**U.S. COMMISSION OF FINE ARTS  
CONCEPT REVIEW SUBMISSION**

**THE WHITE HOUSE VISITOR SCREENING  
FACILITY PROJECT**

EXECUTIVE OFFICE OF THE PRESIDENT/UNITED STATES  
SECRET SERVICE/ NATIONAL PARKS SERVICE

### 2.2 PROPOSED FACILITY - CFA COMMENTS FROM 03/19/2026 CONCEPT SUBMISSION

ELEVATIONS OF EXIT STRUCTURE ON EAST EXECUTIVE AVENUE

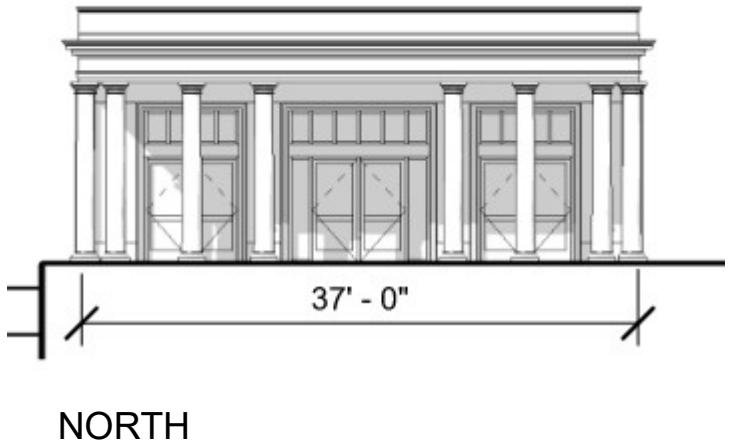
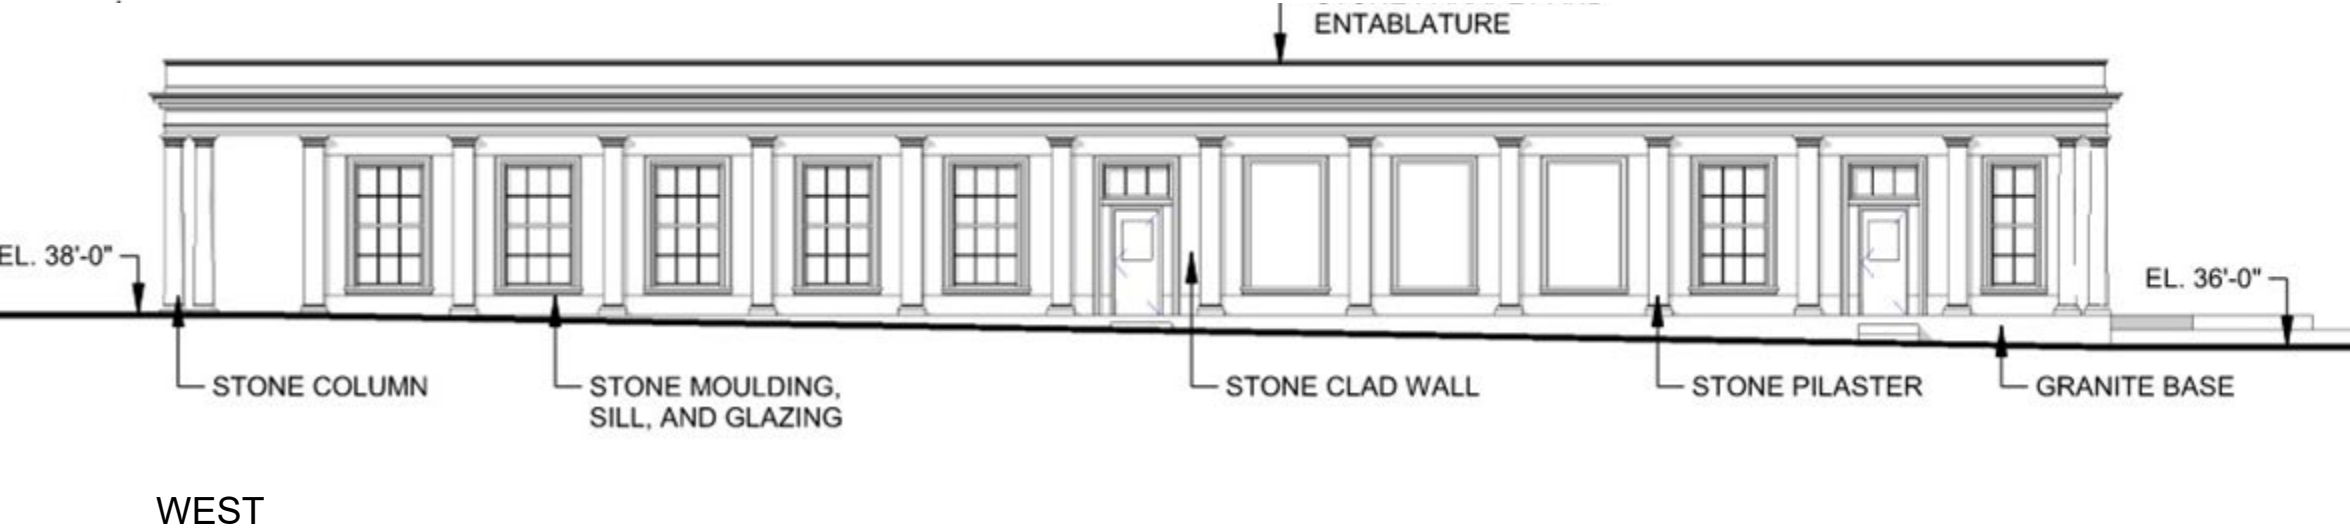
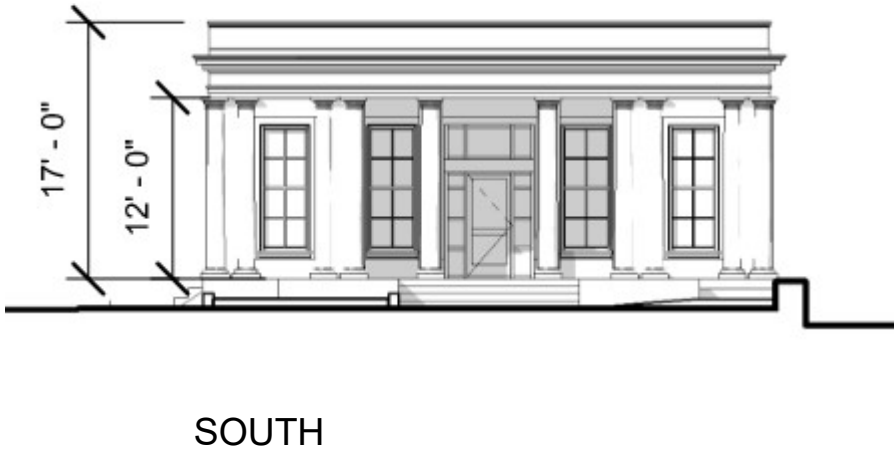
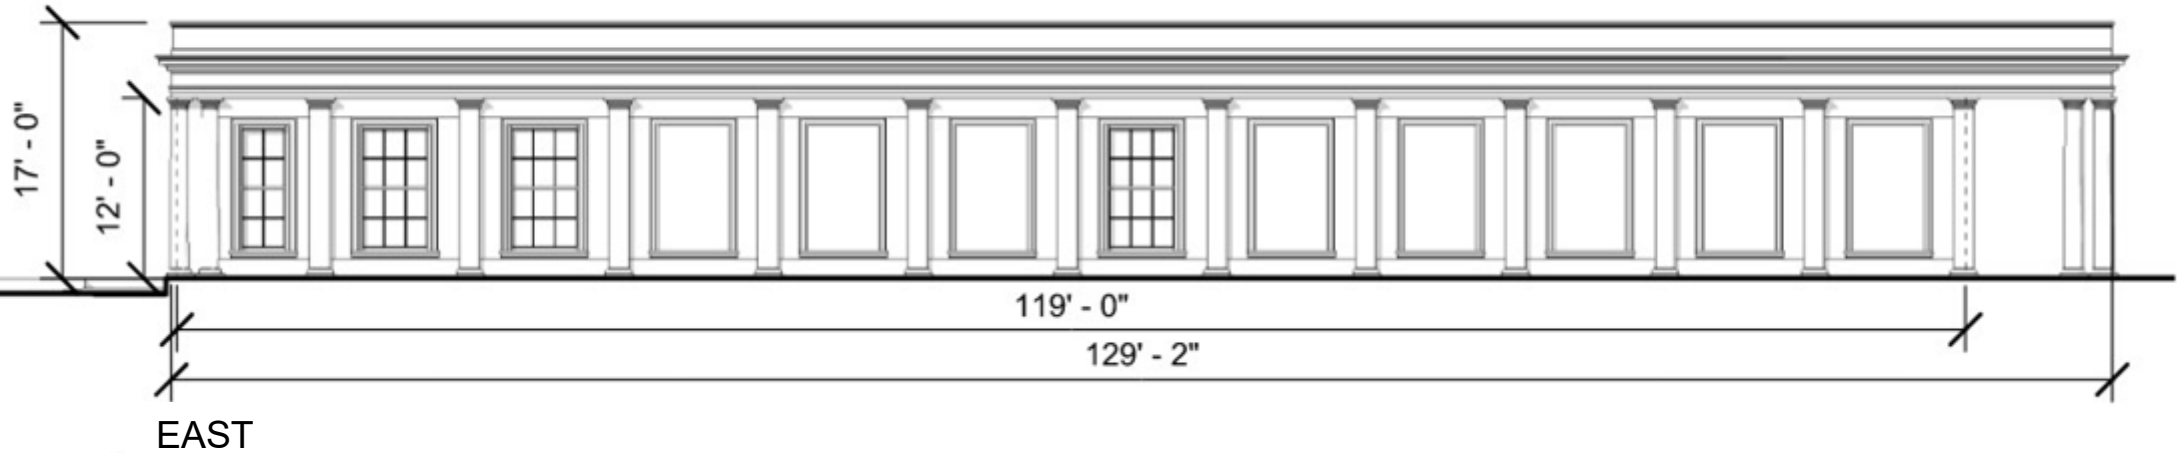
CFA Comment 3/19/2026 -  
Review design to incorporate Executive Order on  
Architecture:

*Exit Building / Staff Screening:*

- Coupled columns on the north and south facades to define entries (shown as Doric order similar to site adjacent West Wing entrance, E/W colonnades, and previous East Wing).
- The building composition incorporates a flat roof with a classically ornate entablature and parapet with stone cladding and granite base.
- Pilasters run along the east and west facades in a regular rhythm with glazing integrated where possible or solid infill within frame.
- Glazing systems will incorporate traditional mouldings and trim in alignment with classical design.
